### **A12 CHELMSFORD TO A120 WIDENING SCHEME – TR010060 WRITTEN REPRESENTATION – EDMUNDSON ELECTRICAL LIMITED 13 FEBRUARY 2023**

**Subject: A12 Chelmsford to A120 Widening Scheme – DCO Scheme  
Assessment of Impacts at Edmunson Electrical Limited and Royal London UK Real Estate Fund, Chelmsford**

**Plate 1: Extract from Development Consent Order ('DCO') Plan**

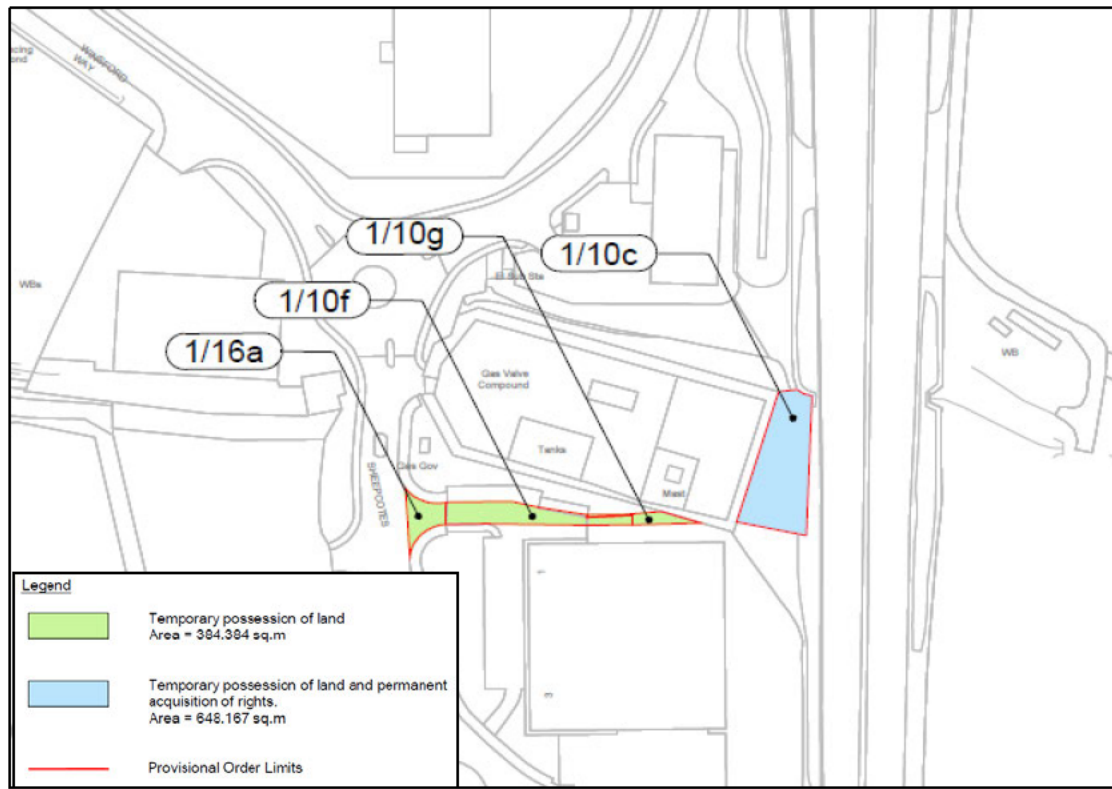
5. The DCO identifies the parcel of land hatched blue, referenced 1/10c, as required to install the proposed diverted gas main works. The parcels of land hatched green referenced 1/16a, 1/10f and 1/10g are identified in the draft DCO as being required for temporary construction access.
6. The 1/10c works as outlined within the draft DCO document states that the works comprise the following:

**Plate 2: EEL in Relation to DCO Route and Sheepcotes (Illustrative)**

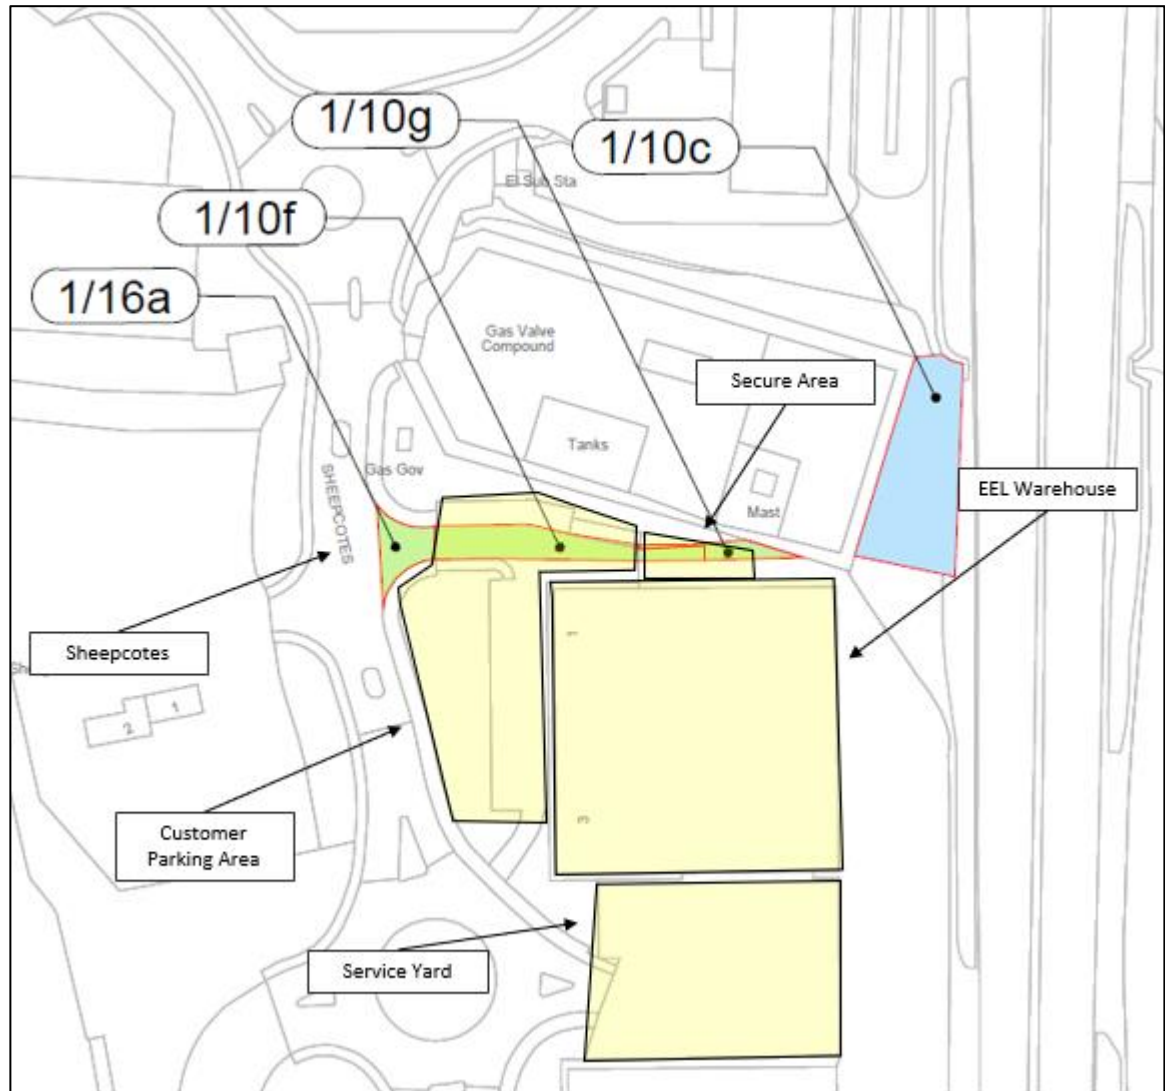
37. The proposed access route passes through the EEL site but ends at the boundary of the gas compound (as shown on Plate 2 above). The route through the EEL site does not connect with land parcel 1/10c. There are no details provided as to how access through the gas compound is to be achieved and it is noted that Cadent themselves object to the proposals. Such details will be required in order for EEL and RL to consider the effects of the proposals on the operation of the EEL site in further detail.

**Plate 4: Order Limits (Extracted from Appendix B of the OCTMP)**

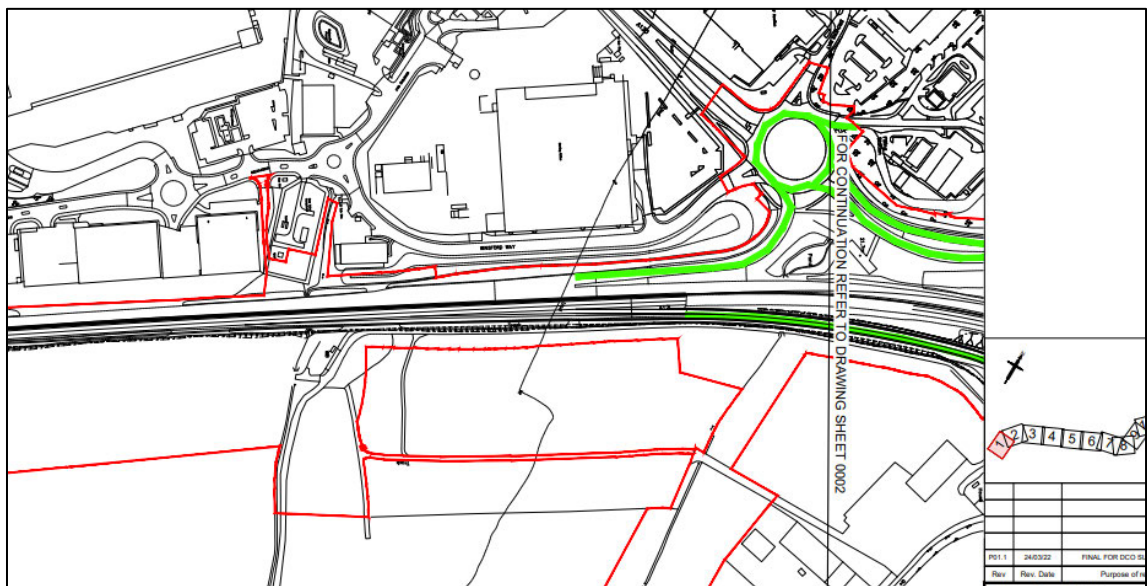
36. The Order Limits includes land on the north side of the gas compound but the application does not include clear or detailed reasons why this alternative route to the gas works site has not been considered appropriate / deliverable.

**Plate 7: Proposed Gas Works Diversion (Extracted from Utility Diversions August 2022)**

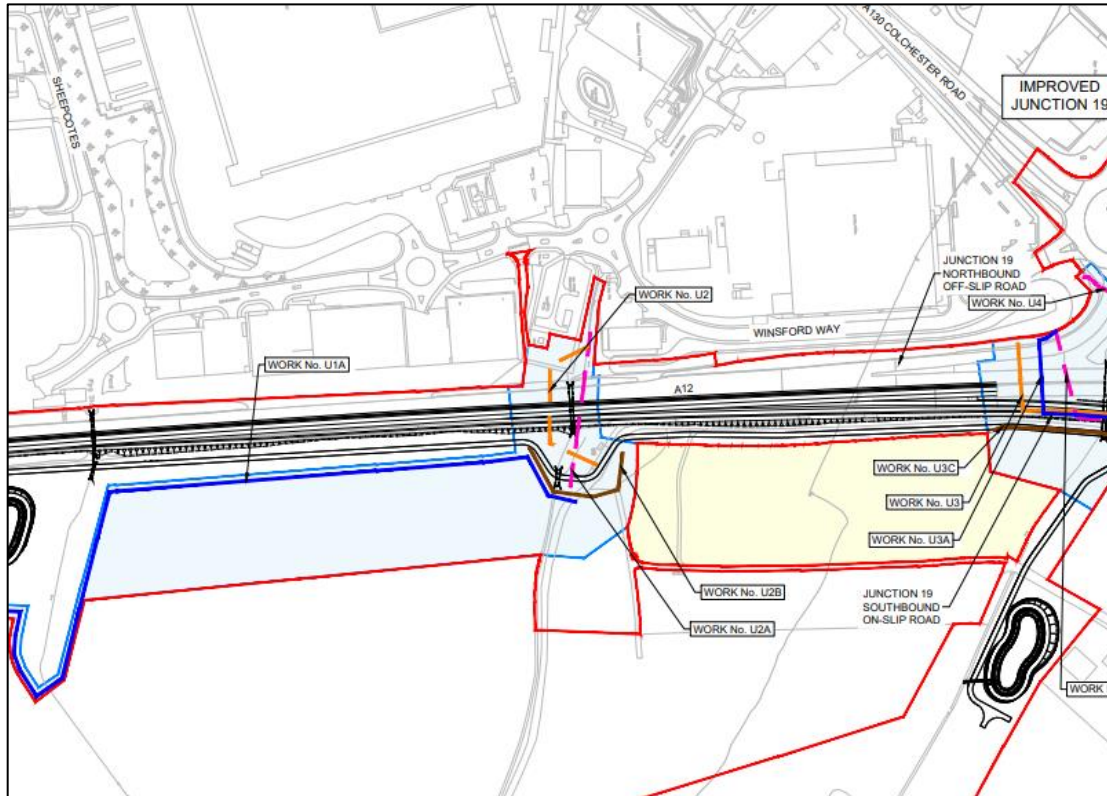
51. There are already a number of utility works planned for the eastern side of the A12 and therefore it is anticipated that there would be a compound for drivers to park. This would also be required for the improvements to Boreham Bridge and Paynes Bridge and will therefore already have infrastructure in place to accommodate construction workers. Any associated compound could therefore be increased in size to accommodate vehicles associated with works for reference: No. U2. This would also reduce the need for any construction related vehicles using Sheepcotes and therefore reducing any potential impact on the EEL site and nearby business park.

52. It is pertinent to note that the pink rectangles on Plate 7 and work reference No. U2A are associated with moving the low voltage overhead cable. It therefore appears that access to the area north of the 1/10c plot will be required, therefore an access through Trilux Lighting or the existing gas works may appear more appropriate.
